INITIAL FIRE SAFETY INSPECTION REPORT

Kenpark Bangladesh Apparel (Pvt.) Ltd.(K-5) (Extension)

RSC ID: 24555

Date: 14/09/2023

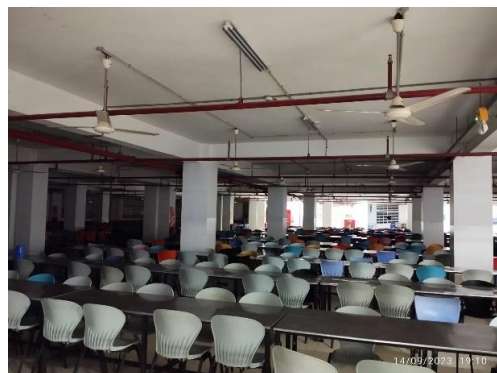
SI No.	Category	Findings	Required Action	Remediation Time Frame
1	Fire Alarm & Detection System (FADS)	The fire alarm and detection system installation requires detailed review to confirm compliance with NFPA 72 and RSC standard.	Submit the fire alarm system design to RSC for review. Once the design is reviewed, install and modify the fire detection and alarm system throughout the building in accordance with review comment, RSC Technical Guidelines (Standard) and NFPA 72. After installation the owner shall conduct internal testing and commissioning and then contact the RSC for witness of final acceptance testing.	Within 2 months for review and 04 months for installation
